MEMORANDUM OF COUNSEL FOR THE APPLICANT RESPONDING TO MINUTE 16

8 August 2025

DELMORE FAST TRACK APPLICATION - RESPONSE TO AUCKLAND COUNCIL FINAL ECOLOGY COMMENTS

SPECIALIST COMMENTS RESPONSE – 88,130,133 UPPER OREWA ROAD AND 53A,53B,55 RUSSELL ROAD, OREWA

PURPOSE OF ISSUE:	FOR INFORMATION
SCALE:	AS SHOWN
DO NOT SCALE	
DRAWING NO:	3725-1-2400
REV:	B

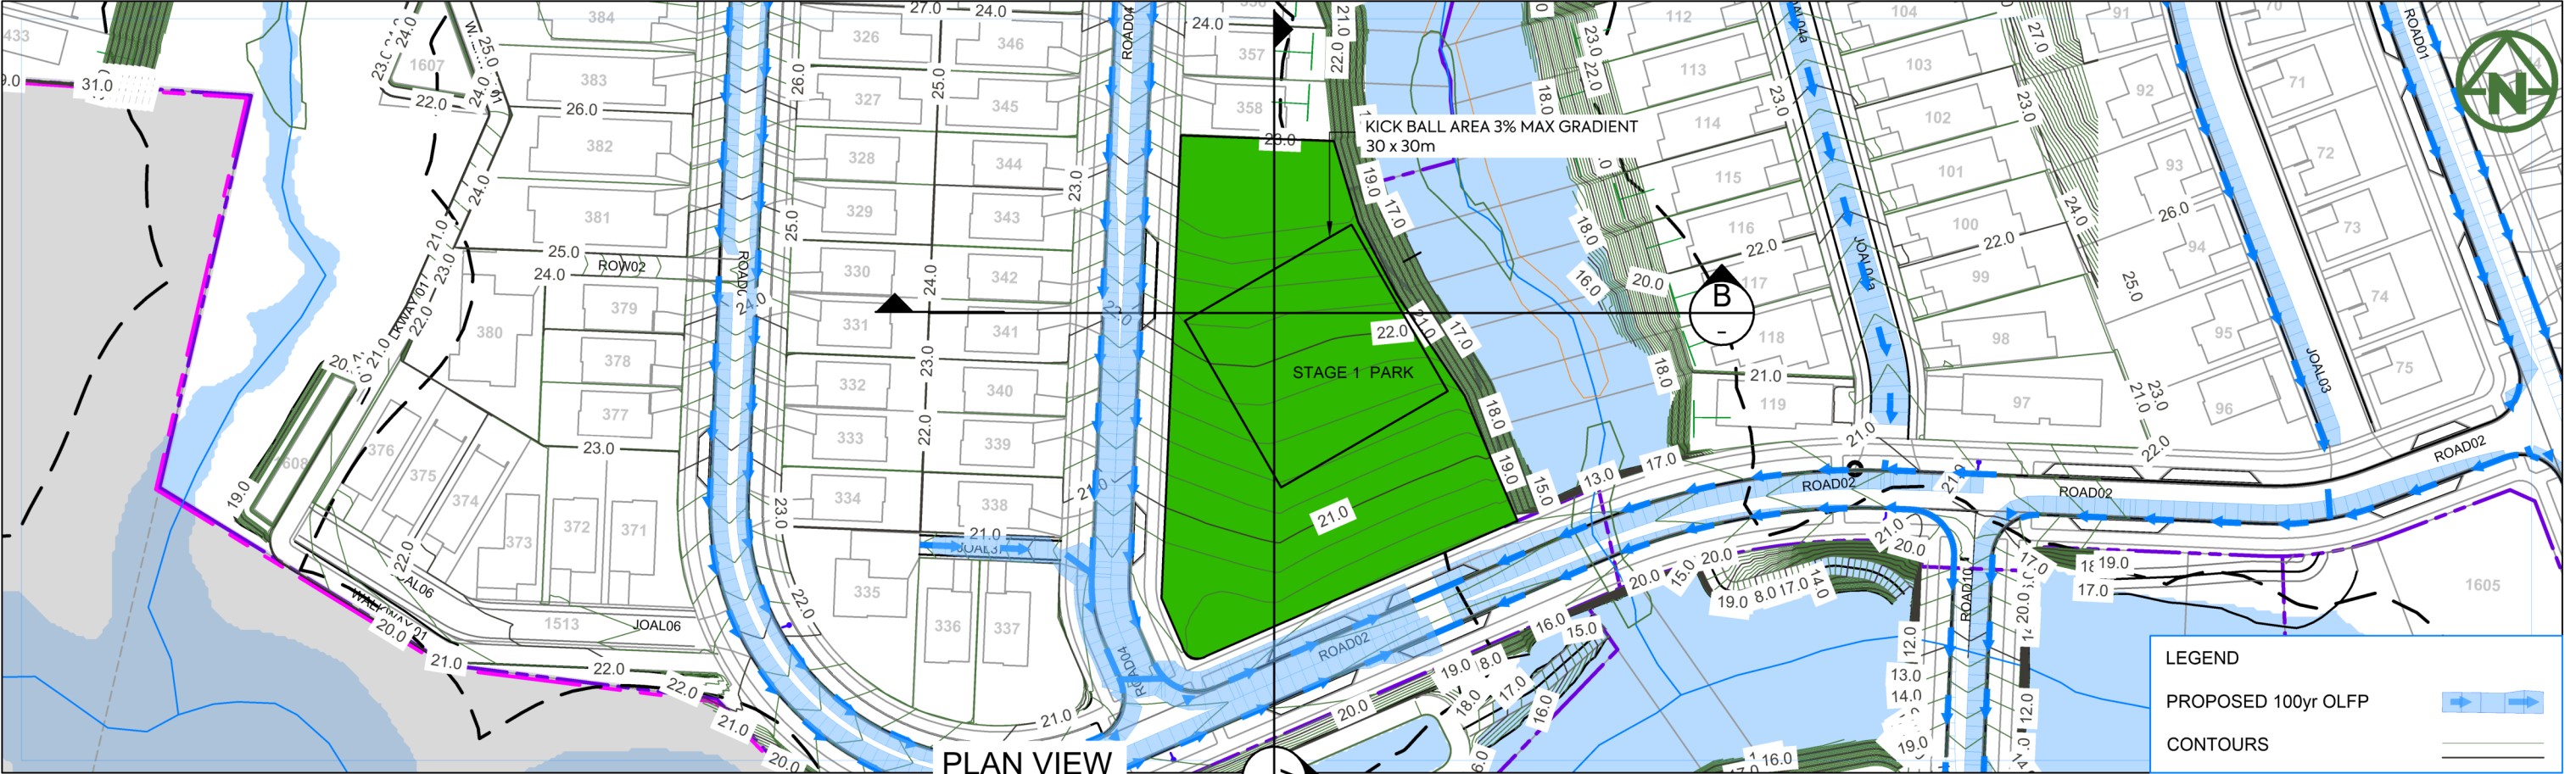
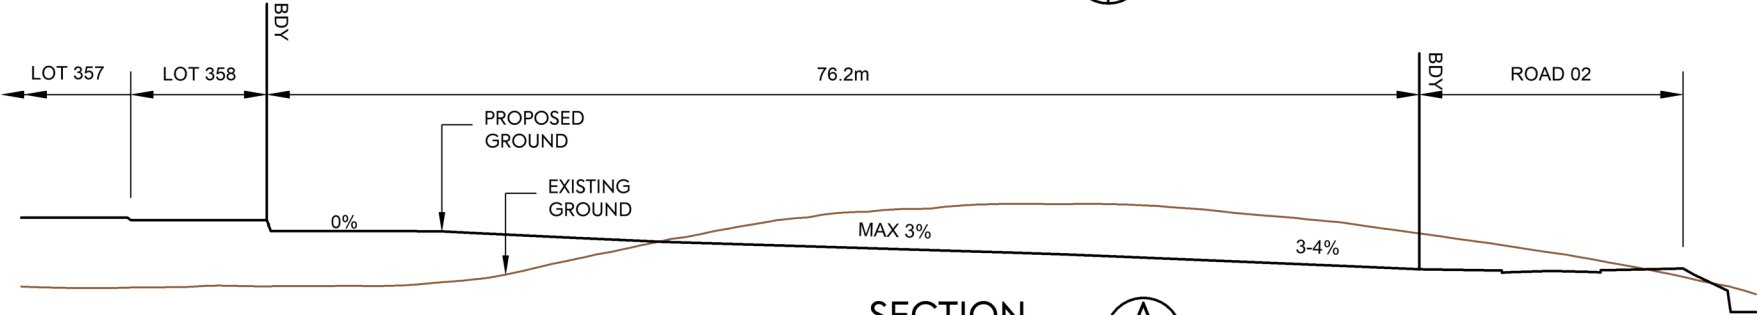
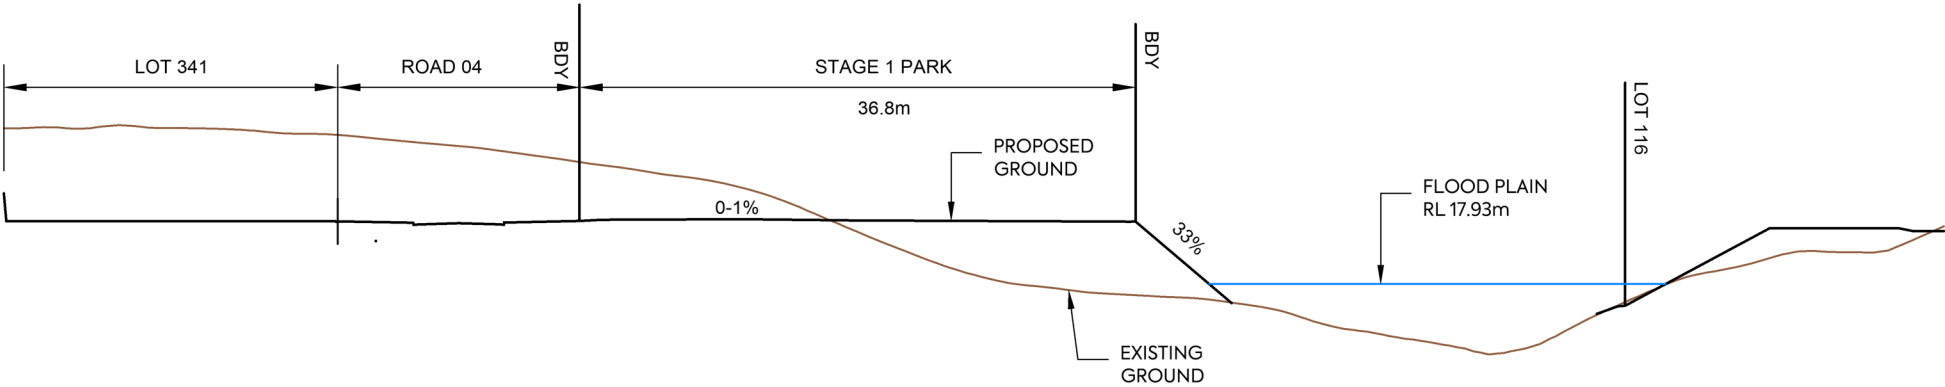
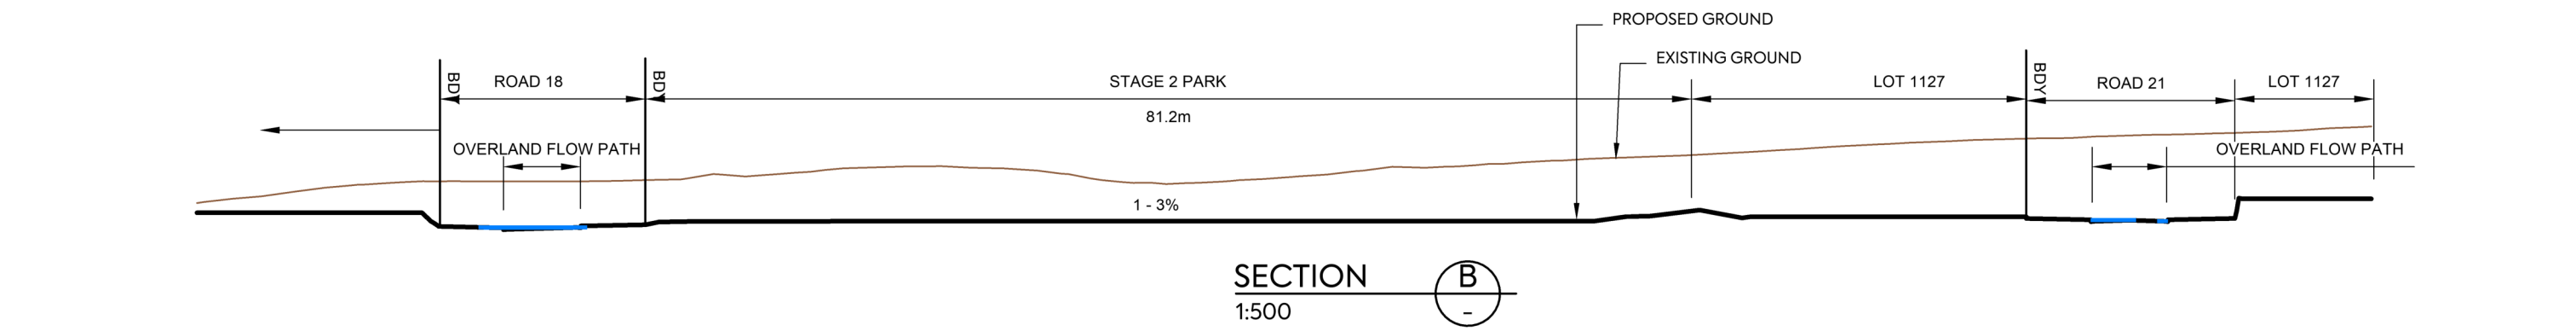
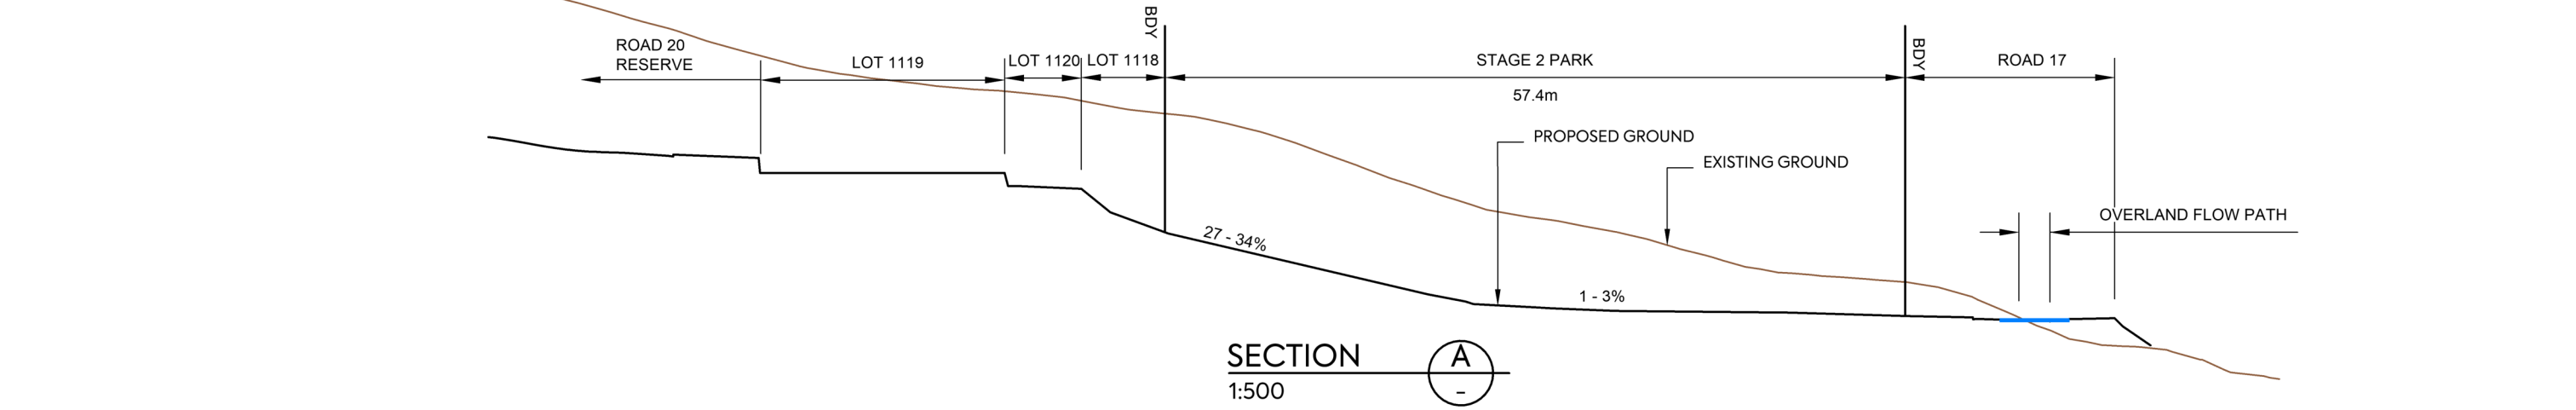
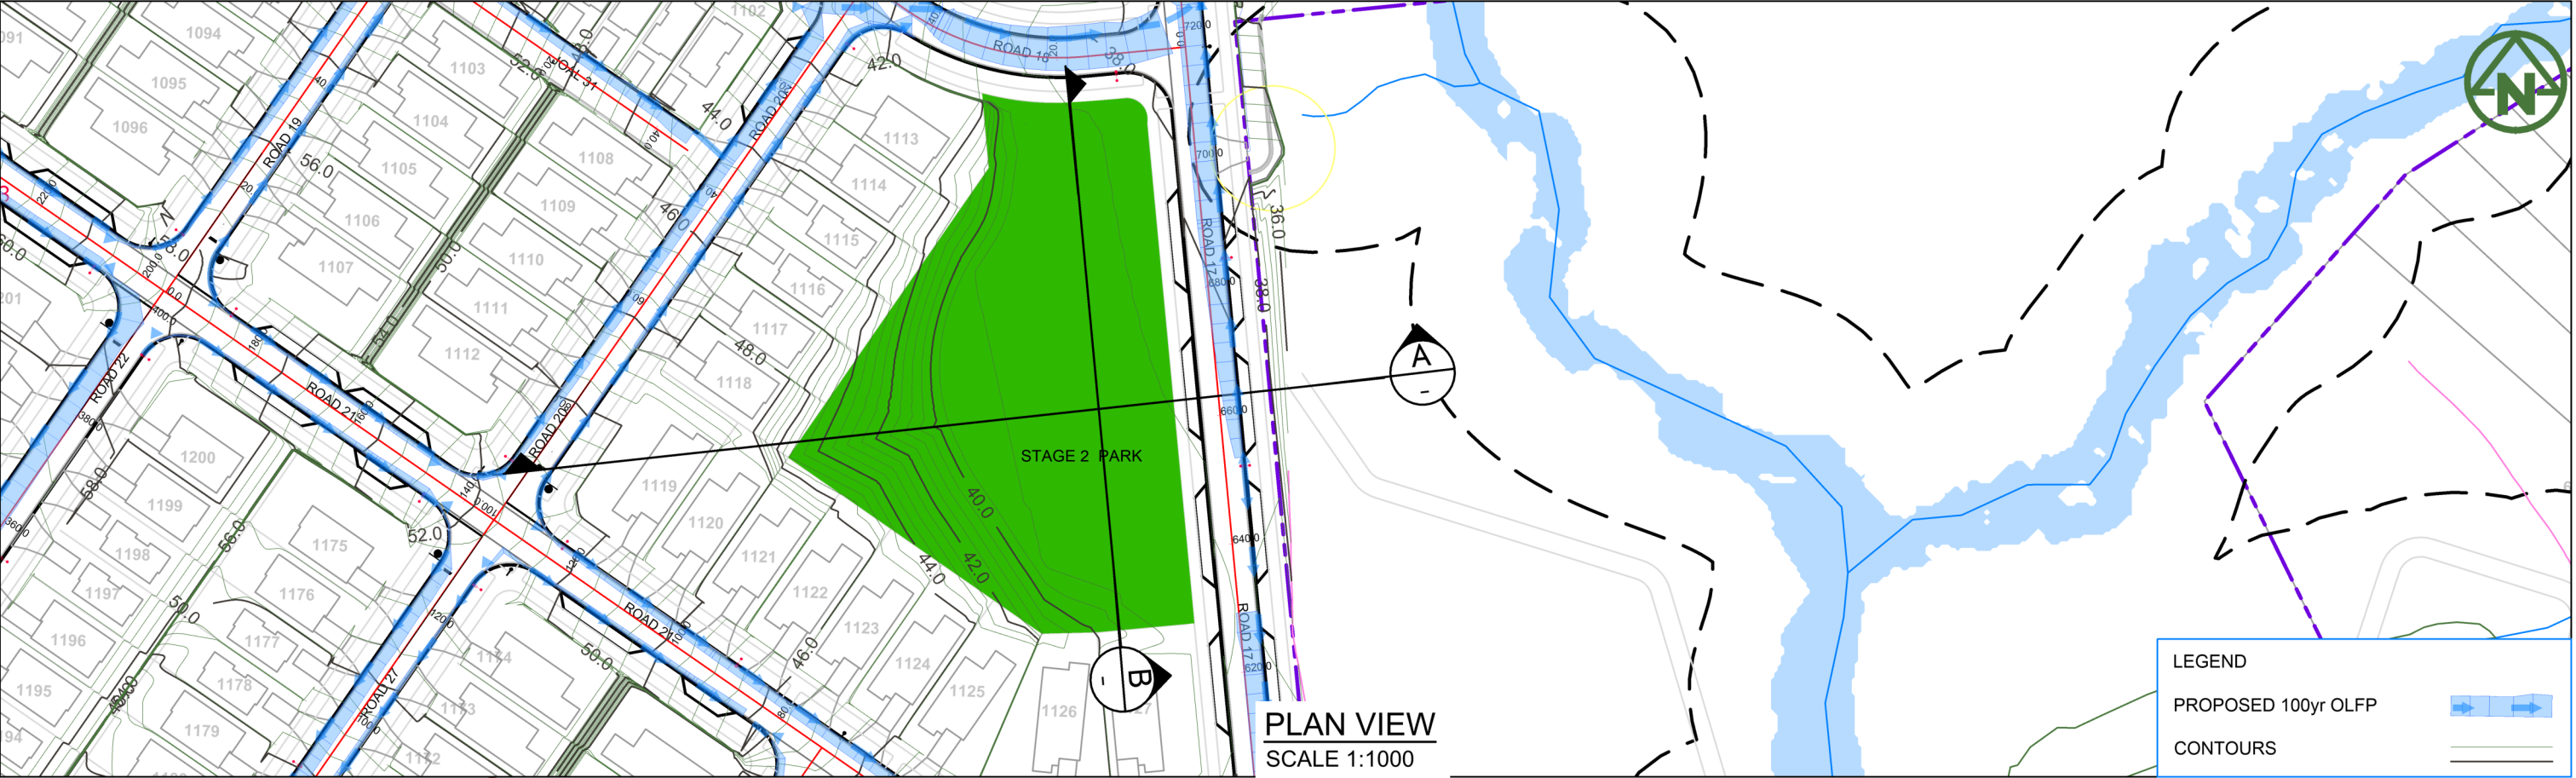
New issue raised about whether grading of the Stage 1 park raises flooding or stormwater implications. This includes a request for commentary and plans showing cross sections for both parks relating to a 1 in 10 and 1 in 100-year flood event

The proposed parks are not subject to inundation from either the 1 in 10-year event, or the 1 in 100-year event. Stormwater flows from the 1 in 10-year event are fully managed by the surrounding piped network, and the parks have been designed so they do not contain any stormwater infrastructure. Both parks are free from the effects of Overland Flow Paths, which are fully contained within the adjacent road reserve, and they are not affected by the 1 in 100-year flood plains, which are entirely contained within the adjacent stream corridors. This is demonstrated in the attached plans and cross sections at Attachment A (stage 1 park: 3725-S1-2400 and stage 2 park: 3725-S2-2400).
